MFN 06-262
Supplement 4

Subject: **Modified Reactor Building/Fuel Building Truncated Model,
SER-ESB-038 Rev. 5**

**Shimizu Engineering Report SER-ESB-038, Rev. 5,
“Modified RBFB Truncated FE Model Analysis Data,”**

Project	General Electric Company ESBWR Project	Shimizu Document No.	SER-ESB-038
Title	Modified RBFB Truncated FE Model Analysis Data	Rev.	5
		Issued Date	9/22/06
		Revised Date	1/9/07

Figure C-35 Element Forces Comparison NASTRAN to ANSYS (Basemat Section B-B: Out-of-plane Shear [MN/m])

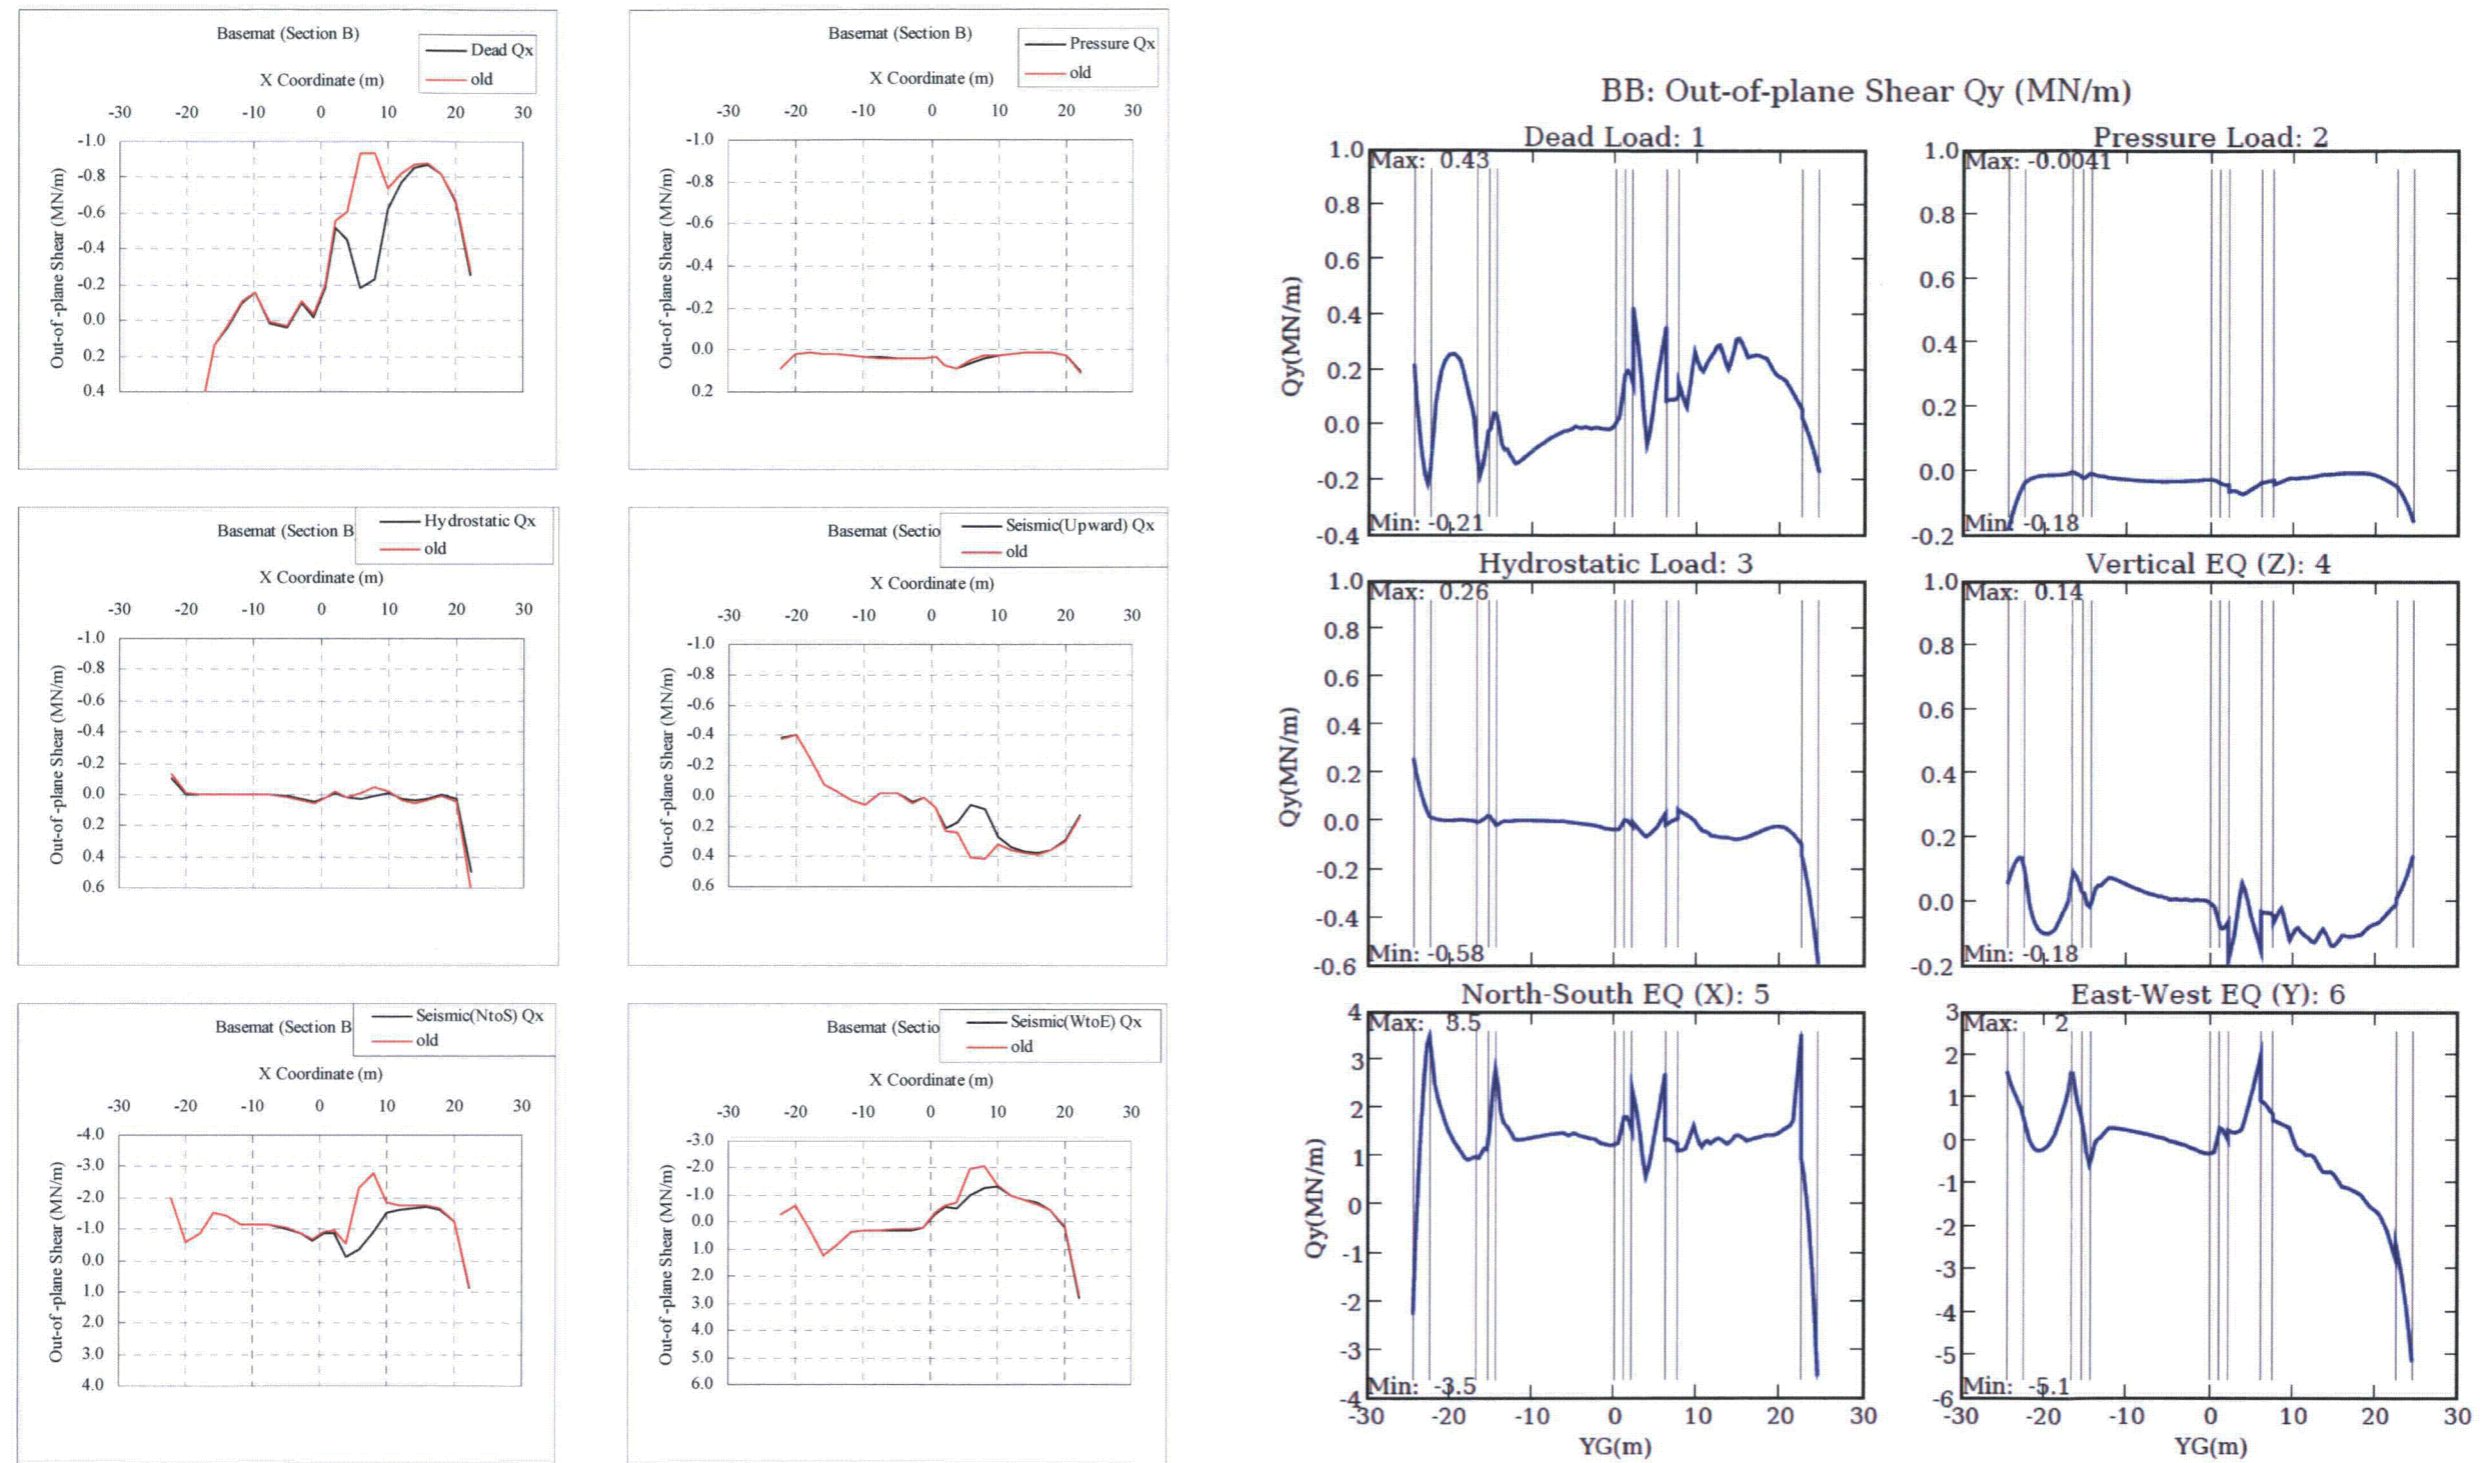
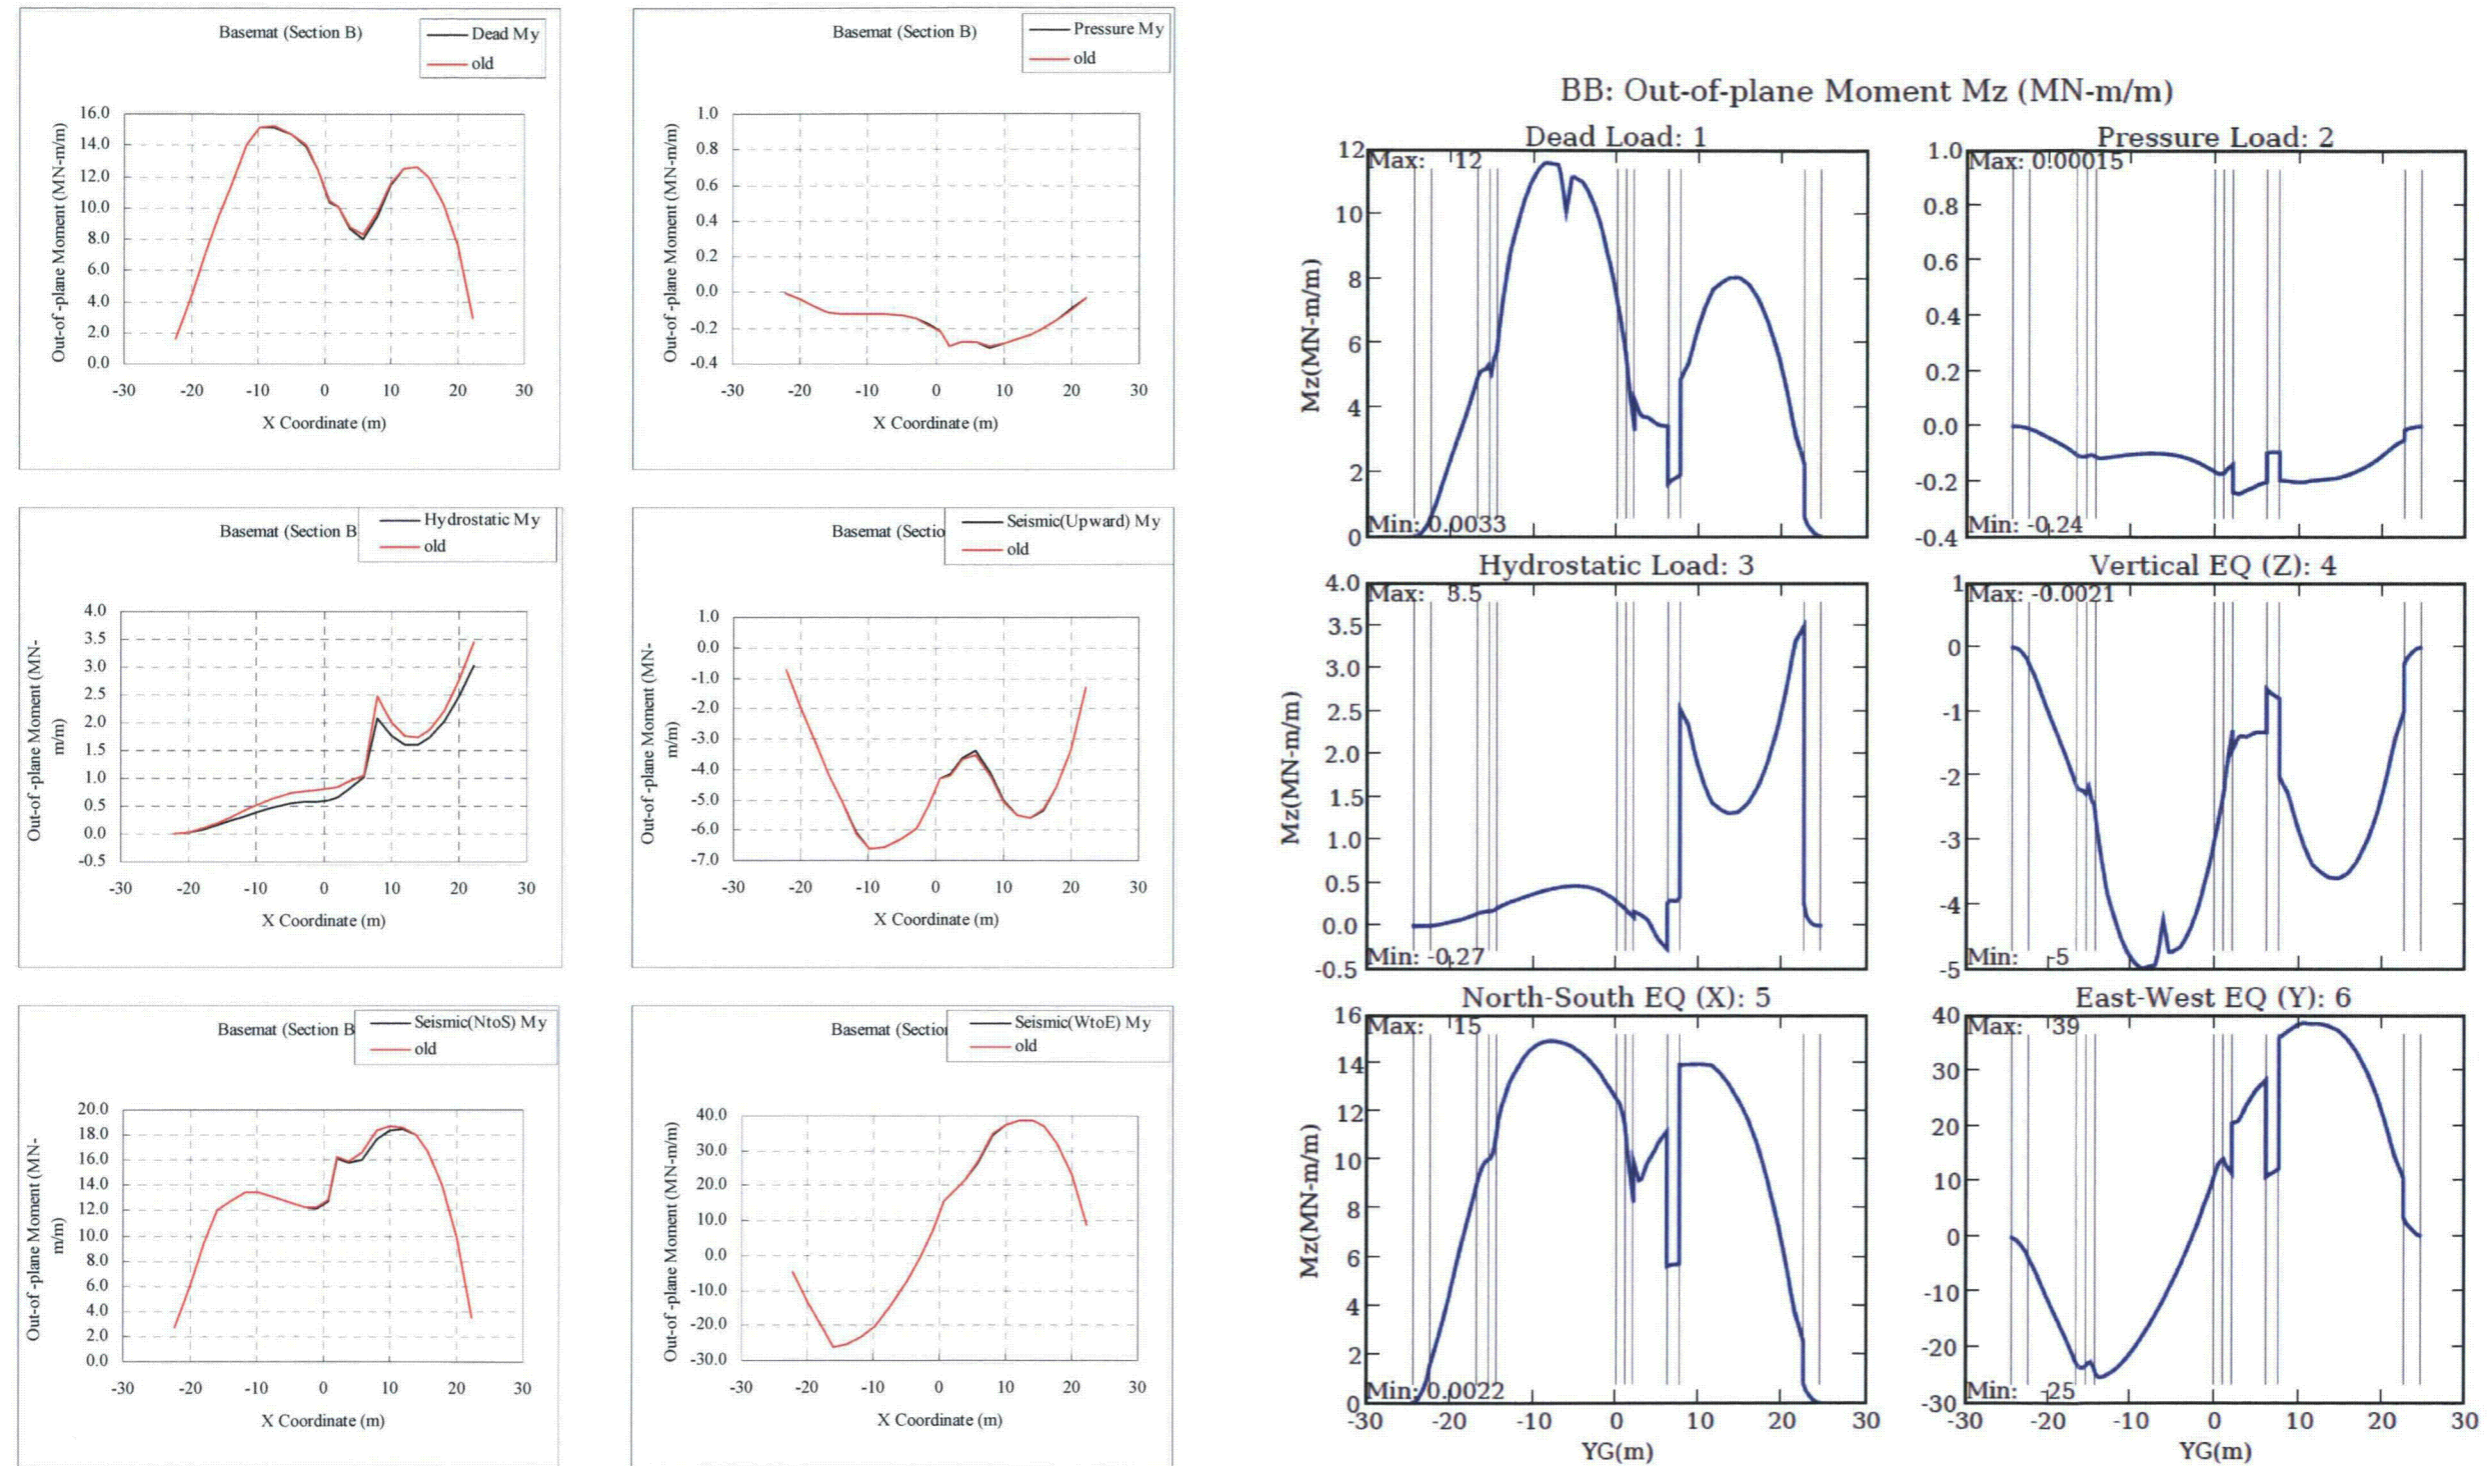
- iii) *The differences of magnitude of forces appeared on basemat inside pedestal:* The result of re-analysis using the updated model shows better agreement. In case of seismic load the magnitude of forces has to be re-compared because BNL's soil spring may not be adequate as pointed out above 3).

- iv) *The differences of magnitude of forces appeared on outer wall of Fuel Storage Pool (FSP):* For the out-of-plane shear forces and moments on RA and F3 wall located around FSP in case of Hydrostatic load, BNL's results are lower than those of GE. GE assumes the some part of differences comes from the difference of estimation levels between both models as pointed out above 8). In order to have a better understanding of the differences, GE would like to request BNL to confirm the input data for Hydrostatic load.
